Product / Process Change Notification (PCN)

PCN #: PCN_WSEN-ITDS_20201120

WSEN-ITDS; 2533020201601,
 WSEN-ITDS; 25330202016011,
 WSEN-EVAL; 2533020201681

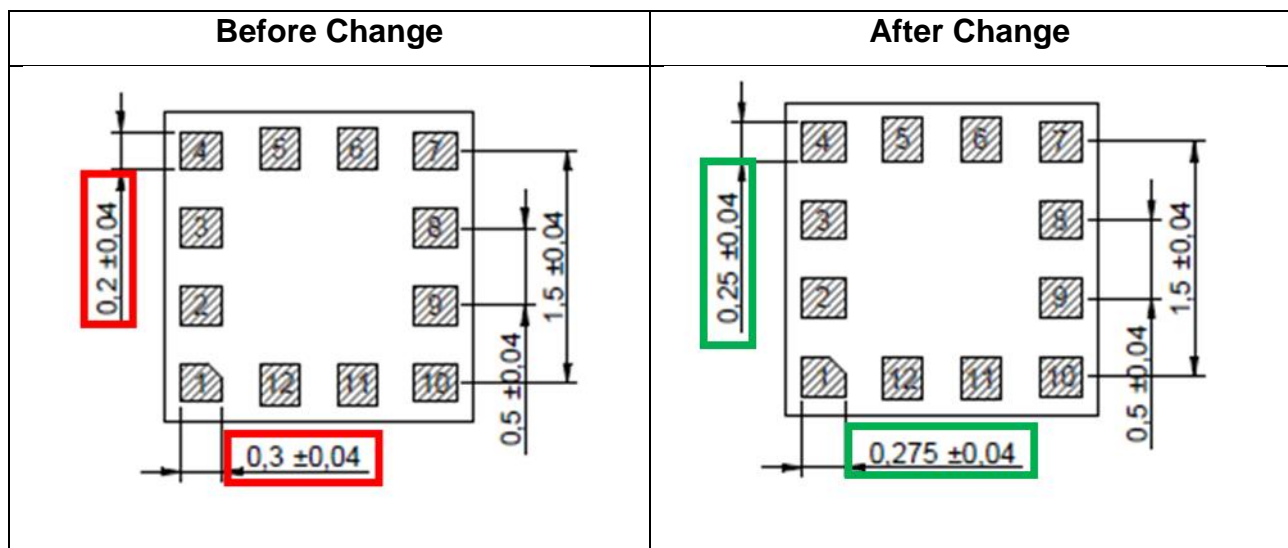
3. Sensor pad dimensions in the CAD drawings were rounded off to one decimal point. This has been changed in the datasheet. The updated dimensions rounded off to two decimal points of the pads are 0.25 x 0.275. Updated information is marked with a red box before change and with a green box after change.
